Intel[®] Pentium[®] III Processor Specification Update

Release Date: November 2001

Order Number: 244453-035

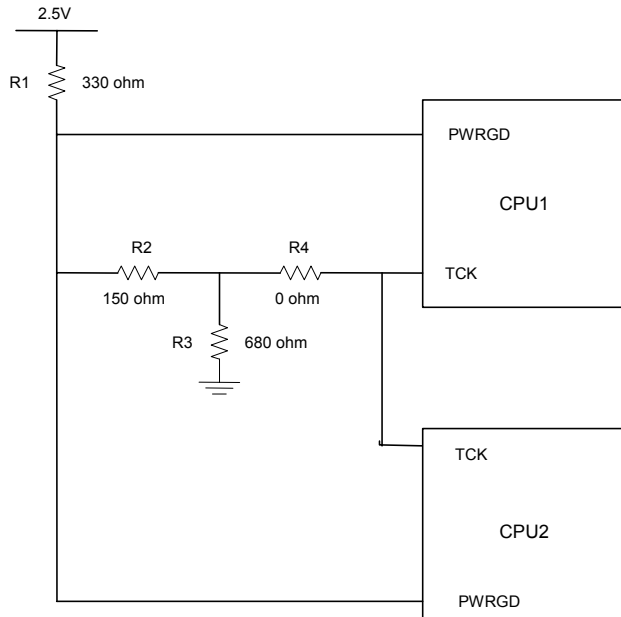
Problem: The internal control register bit responsible for operation of the Thermtrip circuit functionality may power up in a non-initialized state. As a result, THERMTRIP# may be incorrectly asserted during de-assertion of RESET# at nominal operating temperatures. When THERMTRIP# is asserted as a result of this erratum, the processor may shut down internally and stop execution but in few cases continue to execute.

Implication: This issue can lead to intermittent system power-on boot failures. The occurrence and repeatability of failures is system dependent, however all systems and processors are susceptible to failure. In addition, the processor may fail to stop execution during the event of a valid THERMTRIP# assertion resulting in the potential for permanent processor damage.

Workaround: To prevent the risk of power-on boot failures or catastrophic thermal failures, a platform workaround is required. The system must provide a rising edge on the TCK signal during the power-on sequence that meets all of the following requirements:

- Rising edge occurs after Vcc_core is valid and stable
- Rising edge occurs before or at the de-assertion of RESET#
- Rising edge occurs after all Vref input signals are at valid voltage levels
- TCK input meets the Vih min and max spec as mentioned in EMTS
